PROJECT REFERENCE NO. U-4405	SHEET NO. UC-44
DESIGNED BY: AMH	
DRAWN BY: AMH/AB	
CHECKED BY: AMH	
APPROVED BY: MWF	
REVISED:	
NORTH CAROLINA DEPARTMENT OF TRANSPORTATION UTILITIES ENGINEERING SEC. PHONE: (919) 707-6690 FAX: (919) 250-4151

### UTILITY CONSTRUCTION

DOCUMENT NOT CONSIDERED FINAL  
UNTIL ALL SIGNATURES ARE COMPLETED

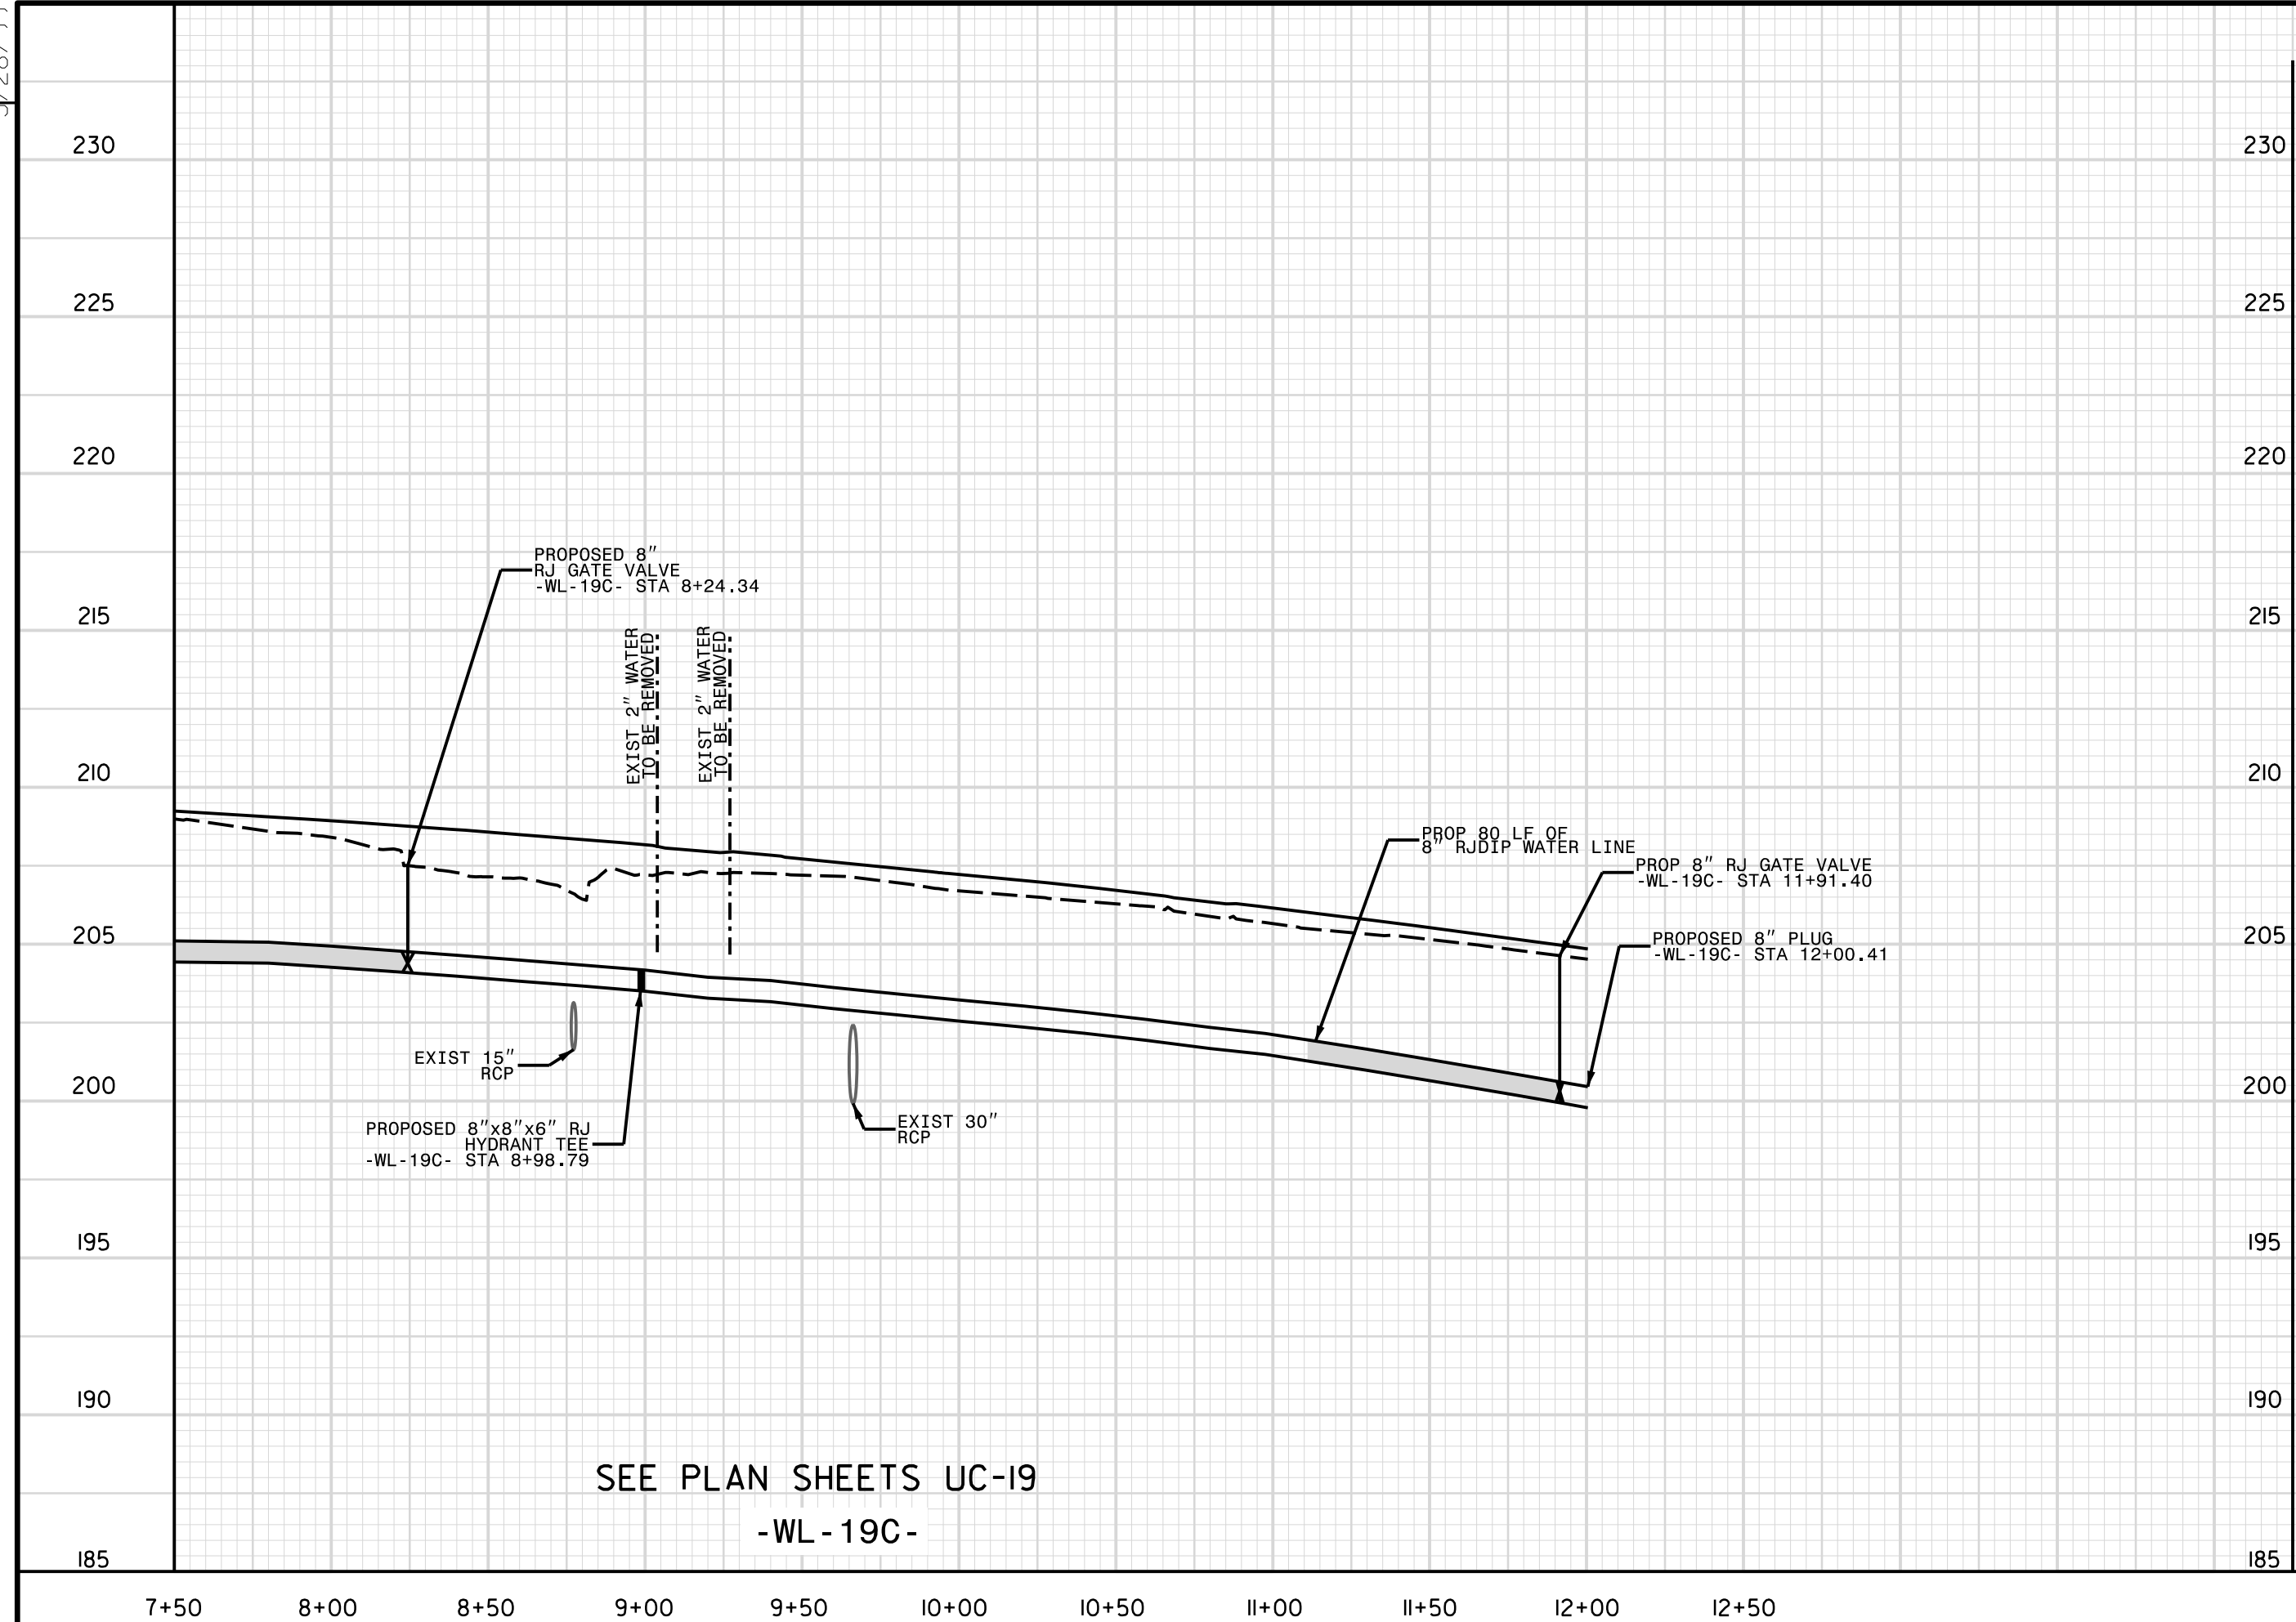
REVISIONS  
 UTILITY REV. - JULY 24, 2008 - SHIFTED VALVE FROM STA. 4+36 TO STA. 4+24  
 - ADDED 80 LF OF R/DIP BEFORE VALVE AT WL-19C STA. 8+24.34  
 - ADDED 200 LF OF R/DIP BEFORE TEE AT WL-20R1 STA. 15+49  
 27 JUL 2008 4:59  
 Public Works Commission (2015017700RA Reeford Road NCDOT PLANS\Utilities\Engineering\UC\Proc\U4405\UCADD\NCDOT PLANS\Utilities\ut\_pf1\_uc44\_psh.dgn  
 8/28/08
